CITY OF ALBUQUERQUE

Re: PNM Mesa del Sol Substation Grading Plan
Engineer's Stamp dated 2-9-07 (R16/D002B)

**MESA DEL SOL SUBSTATION
GRADING PLAN**

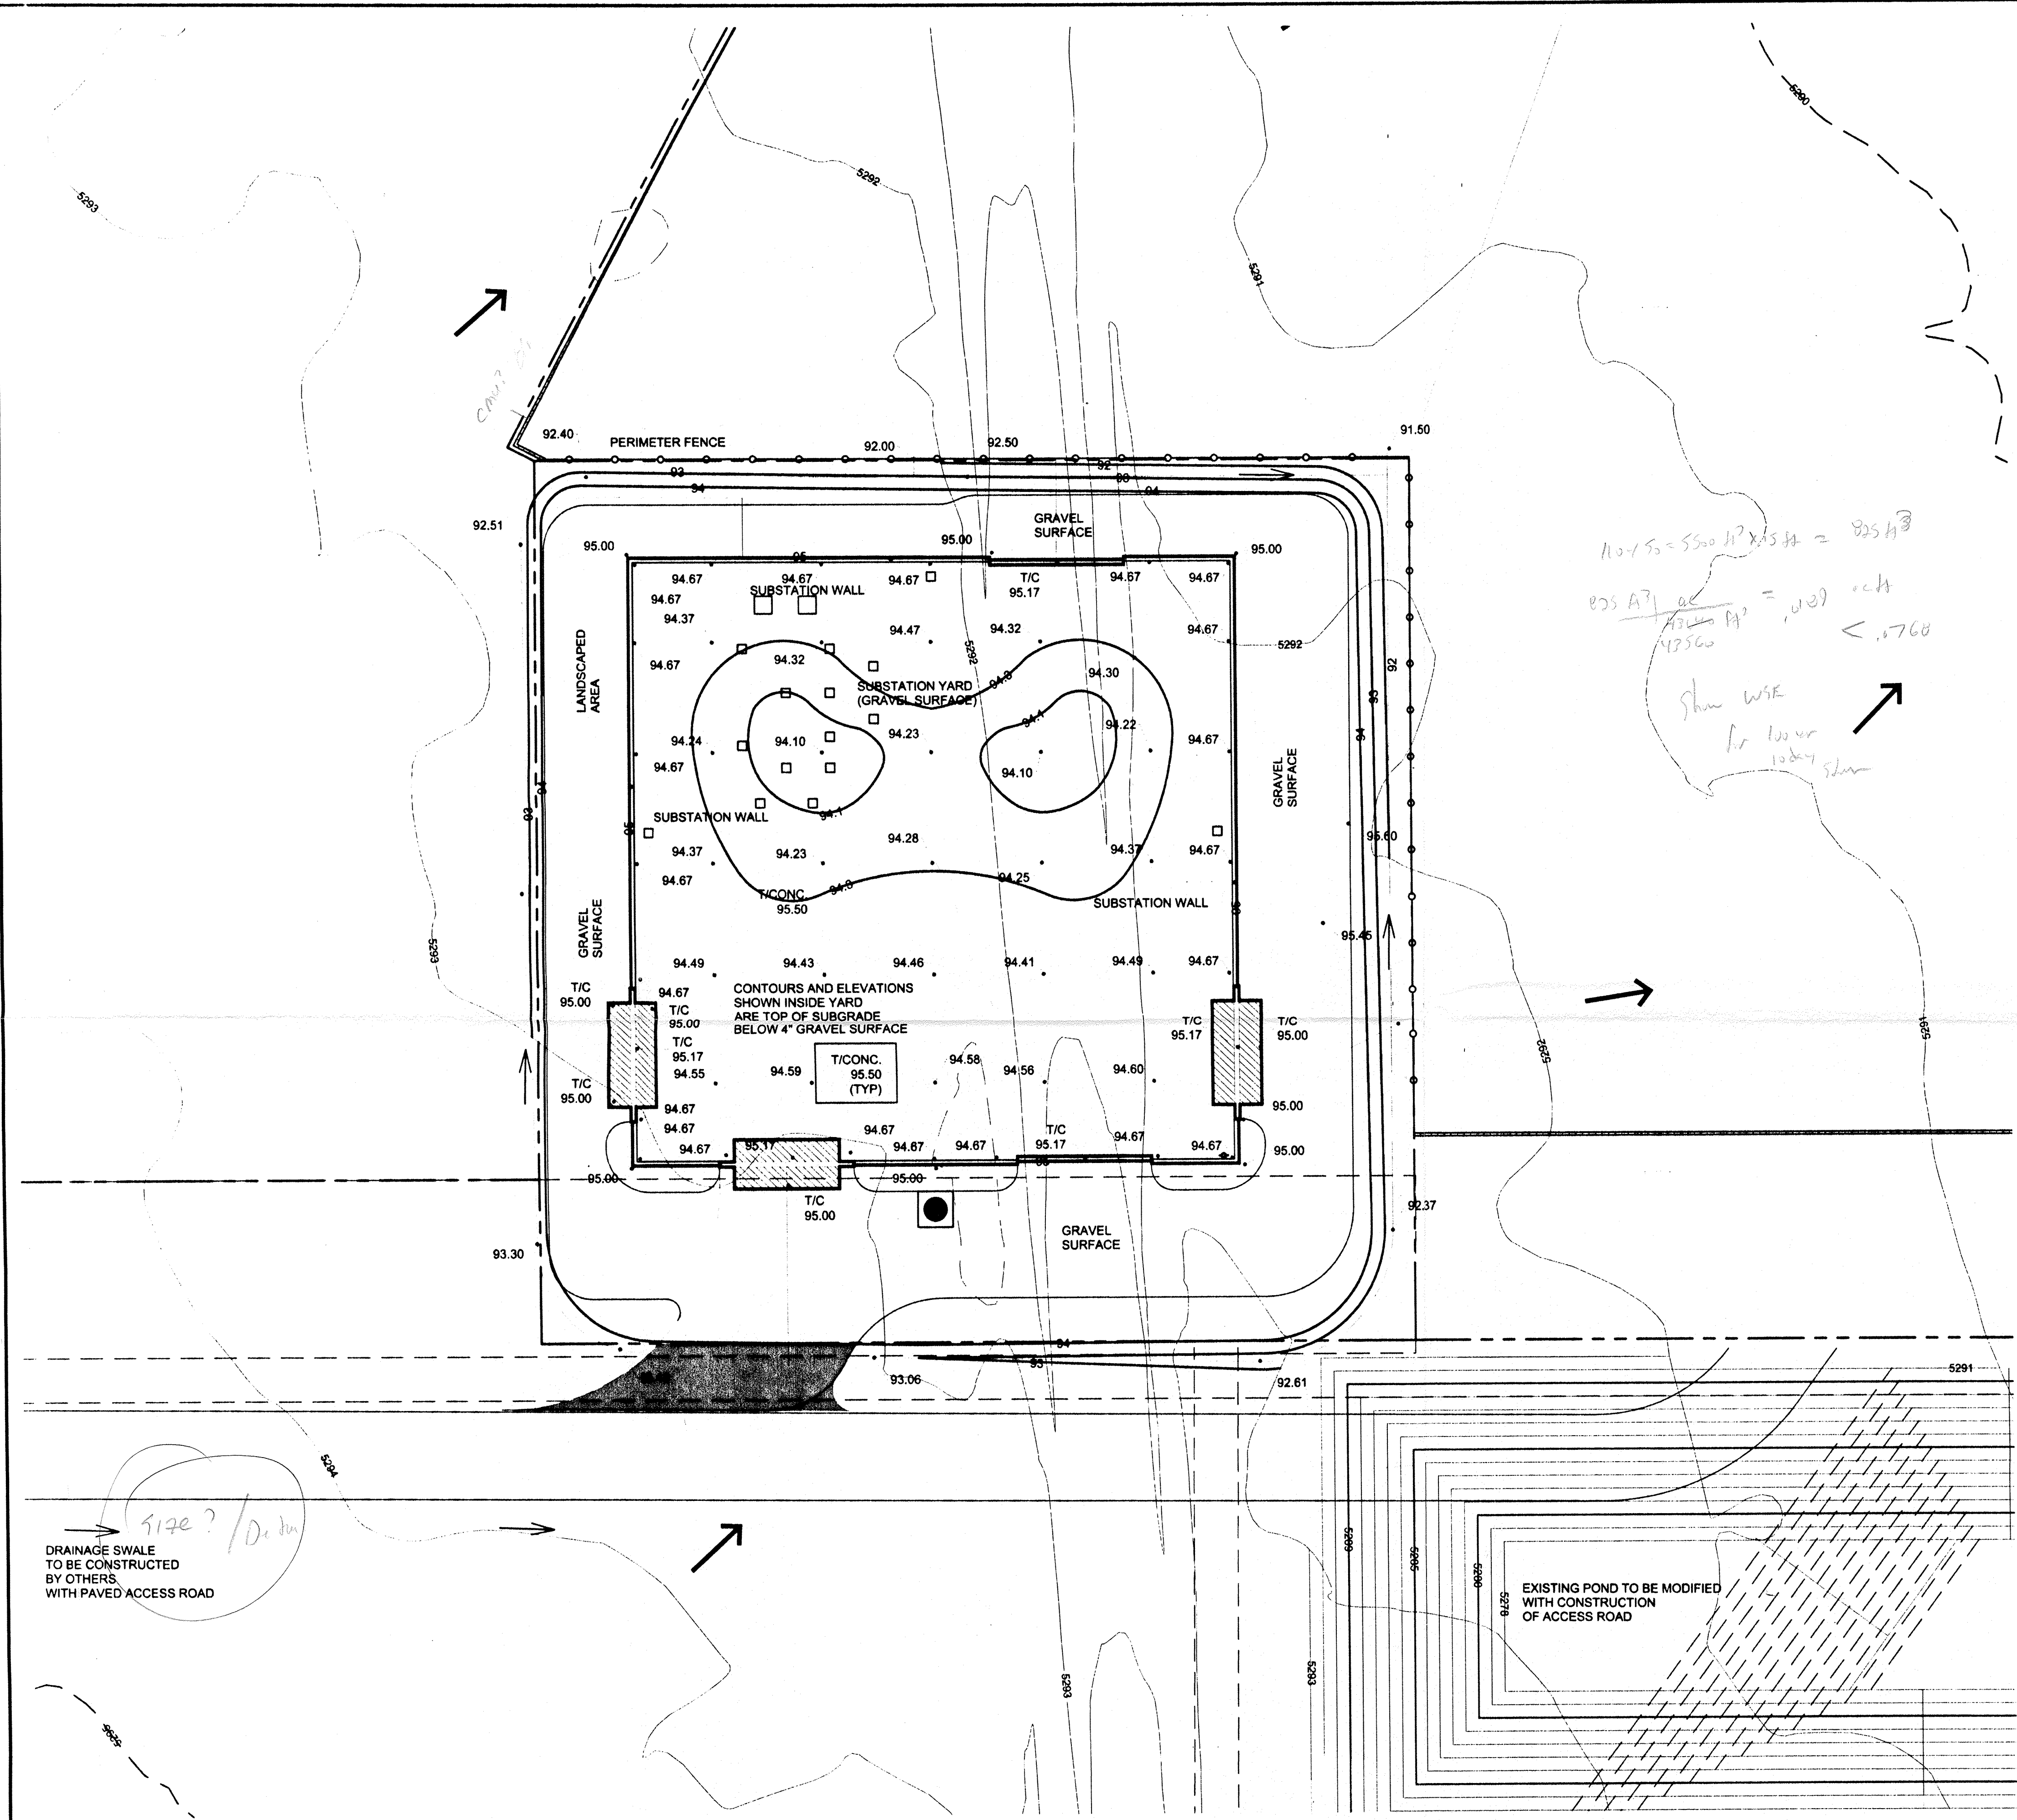
- Provide the ponding volume provided and the water surface elevation inside the enclosure for the 100 yr-10 day storm.
- Provide more detail for the swale on the west side of the road and the modifications to the retention pond.
